SSS-FSAR

QUESTION 211.1

SUSQUEHANNA STEAM ELECTRIC STATION
UNITS 1 AND 2
FINAL SAFETY ANALYSIS REPORT

FSAR FIGURE 211.178-1

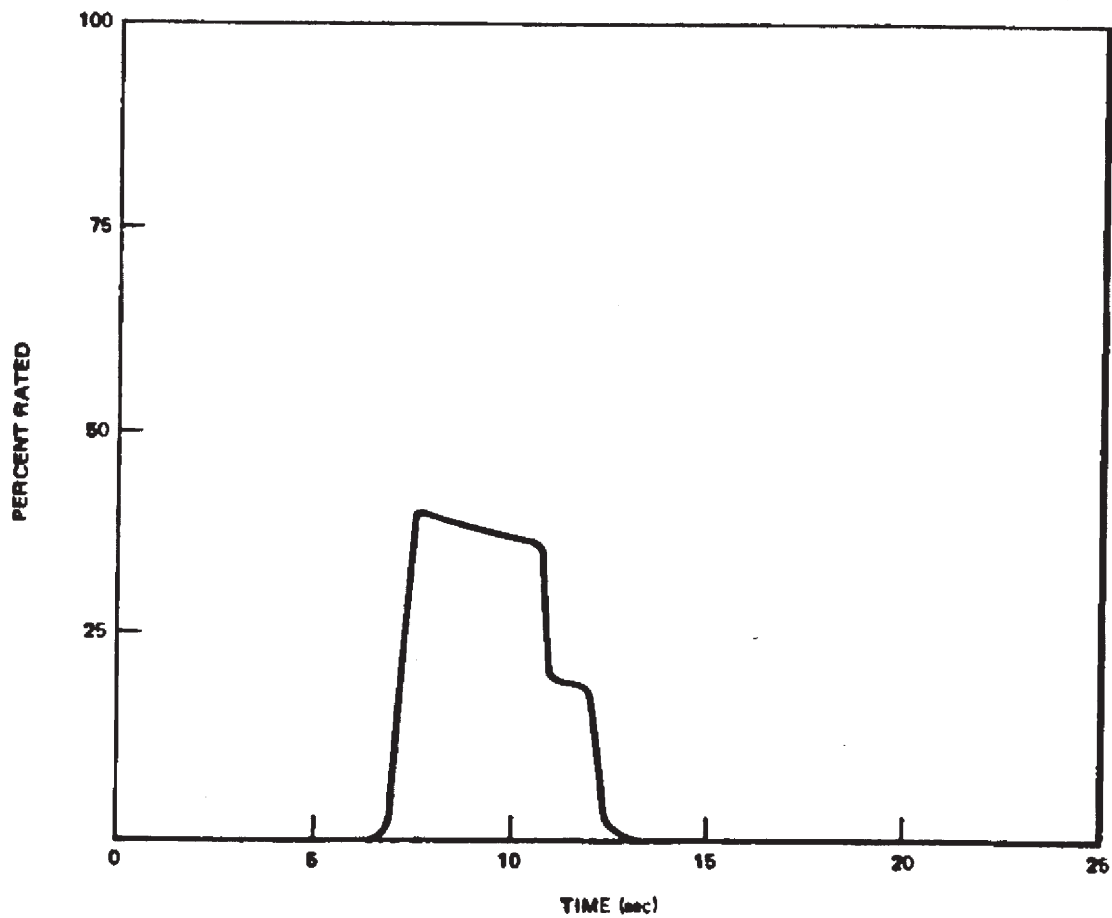
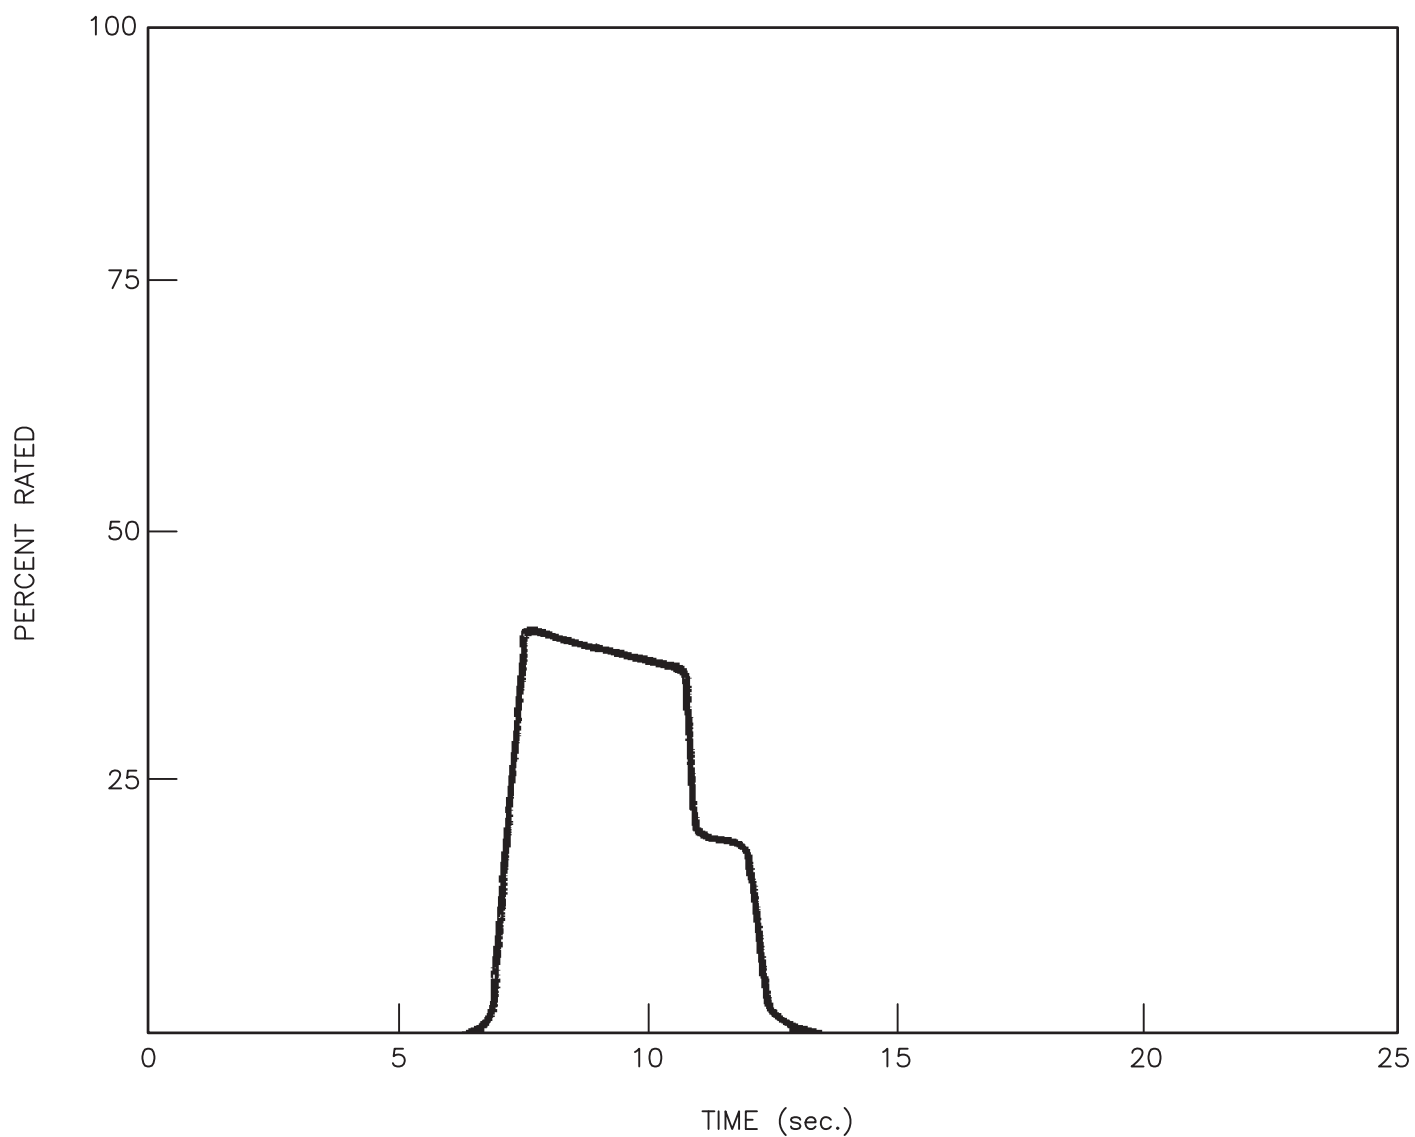
Include relief valve flow in Figure 15.3-2.

Relief valve flow is included in Figure 15.3-2. The upper left quadrant indicates total steam flow, upper right quadrant indicates bypass flow. Since the turbine has been tripped the difference between these flows is the safety relief valve flow. Relief valve flow is shown in Figure 211.178-1.

FSAR FIGURE 211.179-1

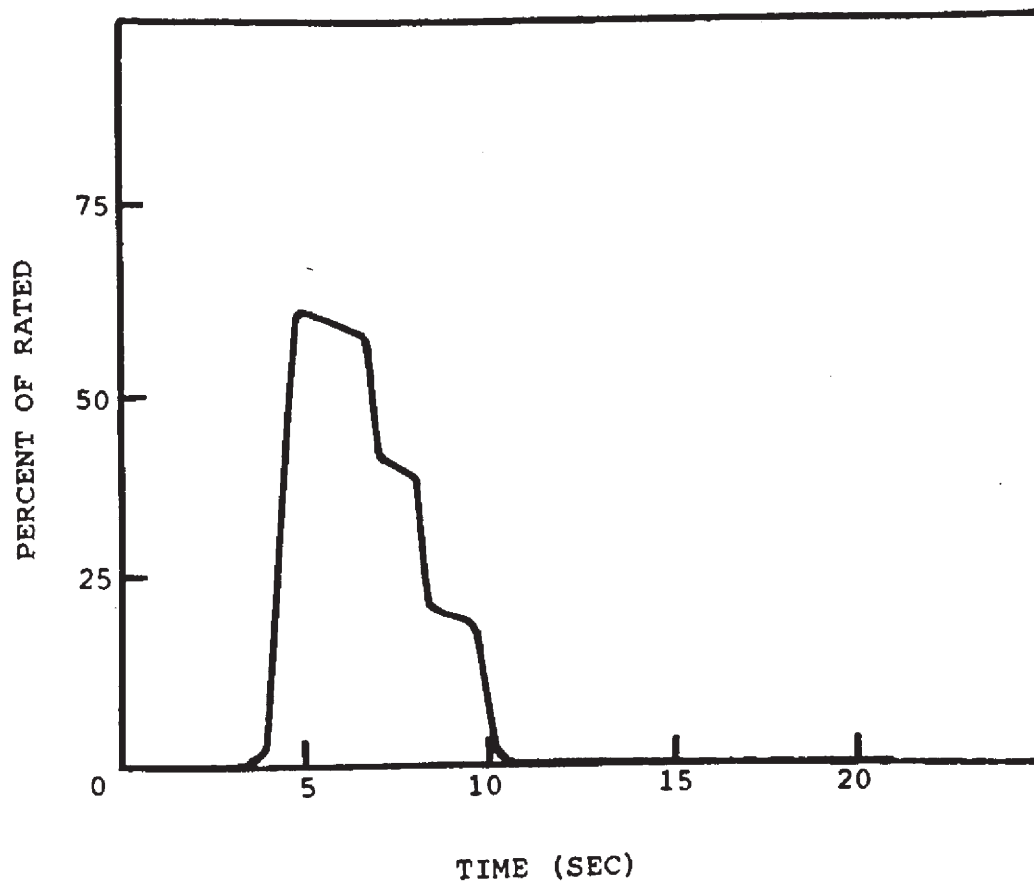
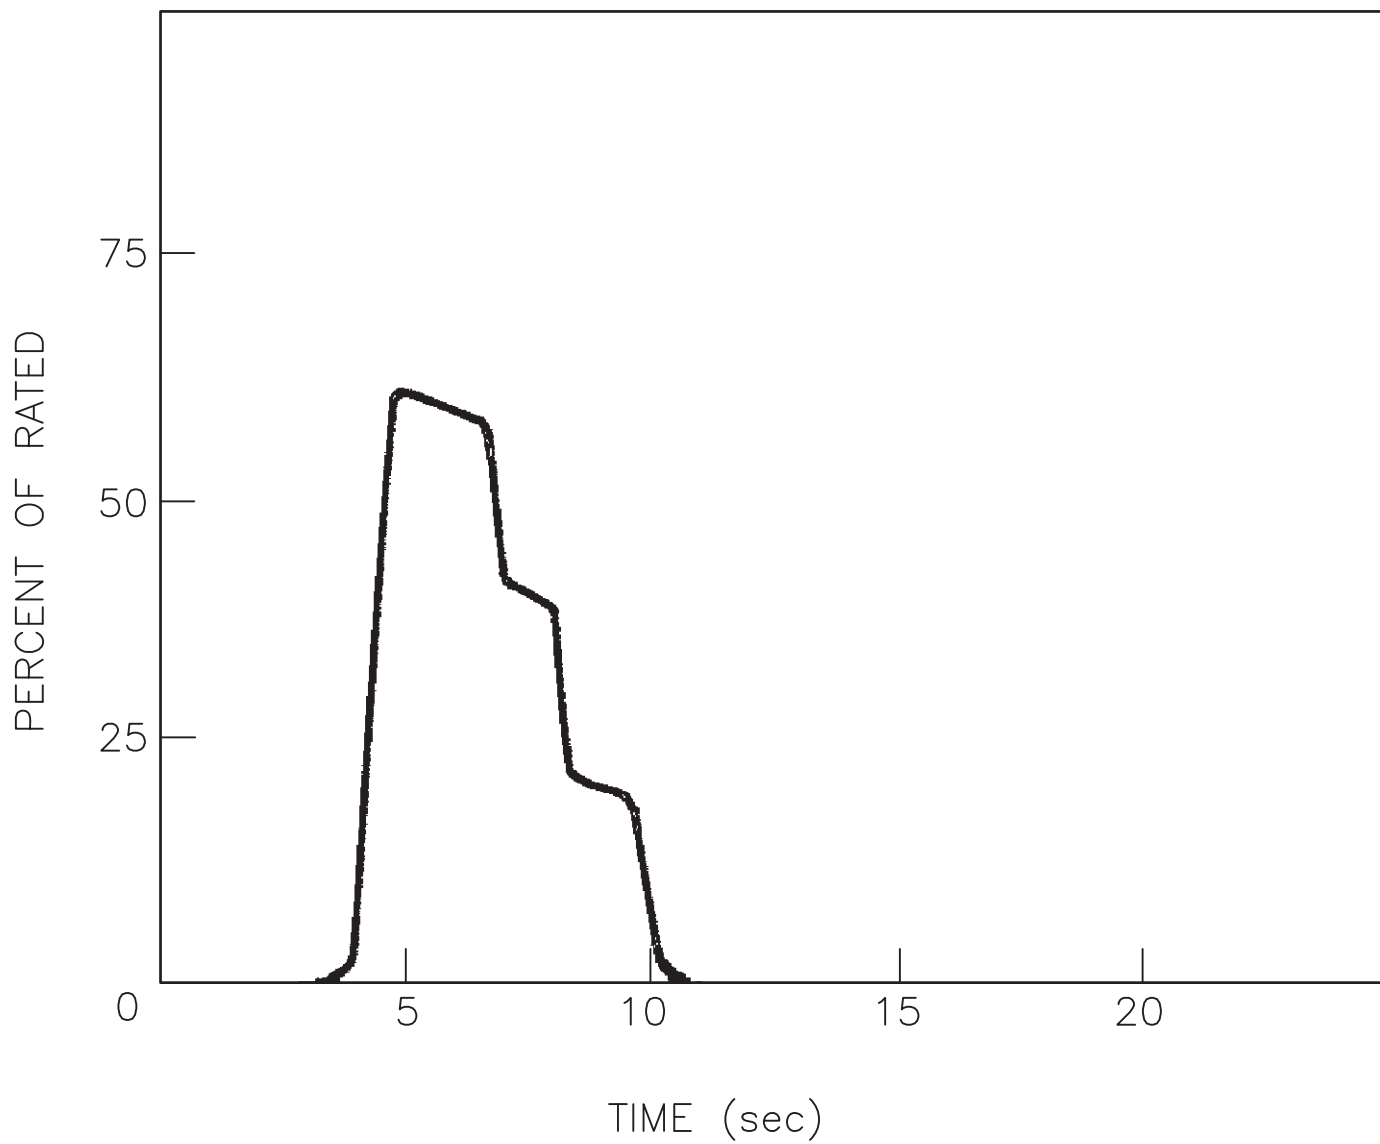
- a) Table 15.3-3 indicates that zero steam flow should not occur until after 41.7 seconds for the "seizure of one recirculation pump" transient. However, Figure 15.3-3 indicates zero steam flow at approximately 35 seconds. Explain this discrepancy.
- b) Include relief valve flow in Figure 15.3-3.

- a) Table 15.3-3 is modified to indicate zero steam flow at 35 seconds when bypass valve closes under control of the pressure regulator.
- b) Relief valve flow is indicated in Figure 15.3-3. The upper left quadrant indicates total steam flow and the upper right quadrant indicates total bypass flow after the turbine valve has been closed. Therefore, the difference is safety/relief valve flow. Relief valve flow is shown in Figure 211.179-1.

FSAR FIGURE 211.227-1

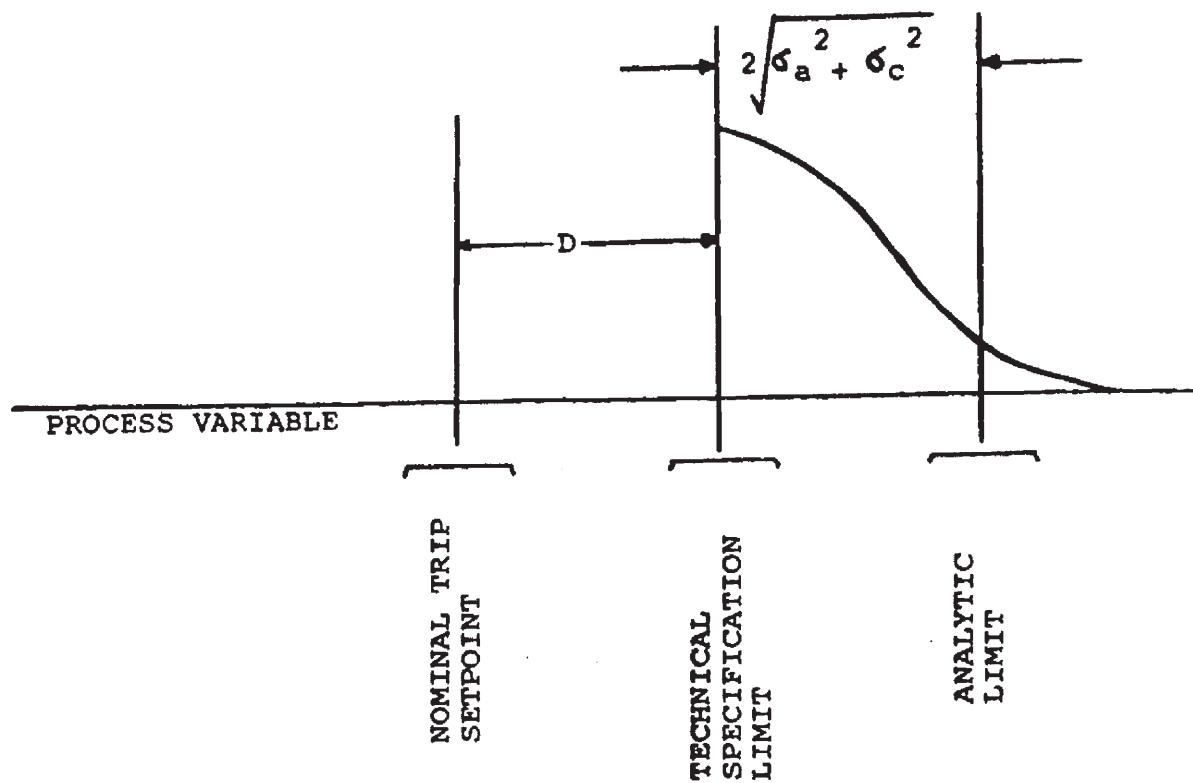
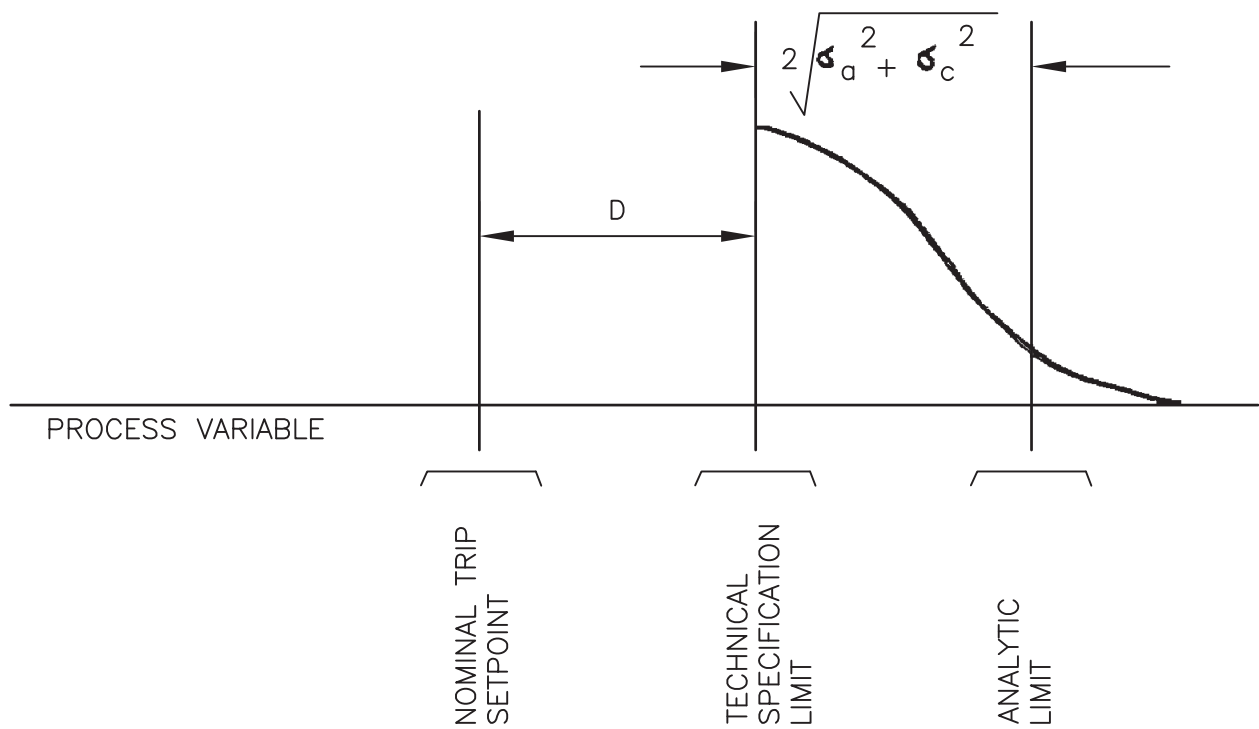
Provide the trip settings and setpoint ranges for the RCIC system isolation instrumentation. Indicate the method of specification of these settings and the provisions for minimizing the potential for inadvertent isolation of RCIC.

RCIC system isolation instrumentation trip setting and setpoint ranges are provided in the plant Technical Specifications. The trip setpoints are established from the analytic limit by allowing for instrument drift and accuracy and calibration capability (see Figure 211.227-1).
